## 3.5L GTDI—INTERMITTENT STUMBLE/MISFIRE ON ACCELERATION FROM HIGHWAY CRUISE IN HUMID OR DAMP CONDITIONS WITH POSSIBLE DTC P0304, P0305, P0306, OR P0430

TSB 13-8-1

2011-2012 F-150

This article supersedes TSB **13-3-3** to update the Service Procedure and Part List.

Figure 2 - Article 13-8-1

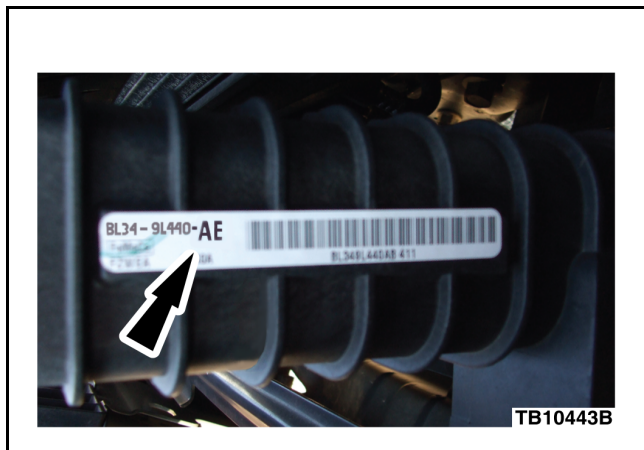
- a. Yes - Proceed to Step 4.
  - b. No - This article does not apply. Refer to PC/ED Manual Section 3: Powertrain Symptom Index to inspect such areas as Ignition, Compression, and Injection.
4. Is vehicle equipped with latest level charge air cooler, engineering part number BL34-9L440-AE? (Figure 2)

CARE NEEDS TO BE TAKEN NOT TO INSTALL THE REVISED BOTTOM AIR DEFLECTOR ONTO CHARGE AIR COOLER ENGINEERING PART BL34-9L440-AE AS IT WILL RESULT IN HIGHER MANIFOLD AIR CHARGE TEMPERATURES AND SIGNIFICANT LOSS OF ENGINE PERFORMANCE.

- a. Yes - This article does not apply. Refer to PC/ED Manual Section 3: Powertrain Symptom Index to inspect such areas as Ignition, Compression, and Injection.
- b. No - Proceed to Step 5.

Figure 3 - Article 13-8-1

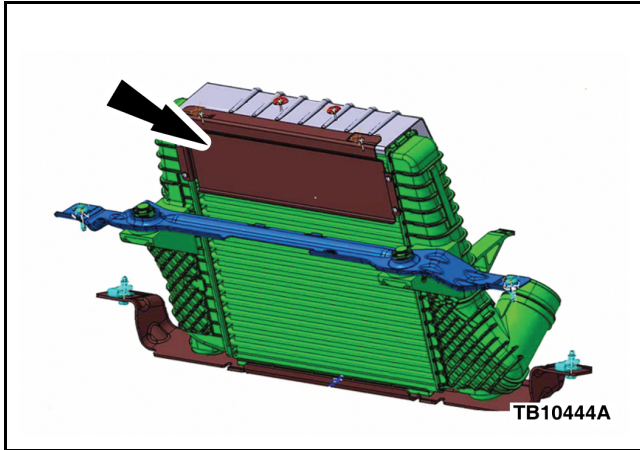
- 5. Is DTC P0430 present?
  - a. Yes - replace the left hand catalytic converter. Refer to Workshop Manual (WSM), Section 309-00. Proceed to Step 6.
  - b. No - Proceed to Step 6.
- 6. Is the Charge Air Cooler equipped with the top air deflector? (Figure 3)

- a. Yes - remove and discard. Refer to WSM, Section 303-12. Proceed to Step 7.
  - b. No - Proceed to Step 7.
7. Install revised bottom air deflector.
- a. Make sure that the lower forward facing bottom seven (7) tubes and eight (8) rows of fins on the Charge Air Cooler are dry and free of dirt and debris. (Figure 4)

Figure 5 - Article 13-8-1

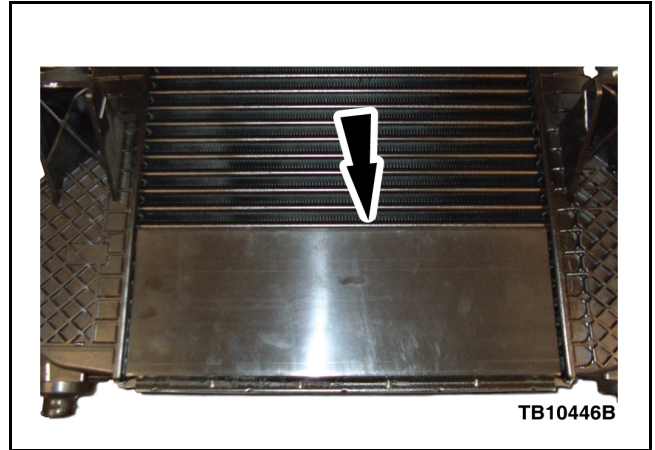
- b. Clean the charge air cooler lower forward facing bottom seven (7) tubes and eight (8) rows of fins by wiping surface down with isopropyl alcohol.
- c. Peel the protective tape off the adhesive side of the deflector.
- d. Install the deflector onto the charge air cooler core surface insuring the forward facing bottom seven (7) tubes and eight (8) rows of fins are covered and pressing firmly into place by hand maintain even pressure for 30 seconds. (Figure 5)
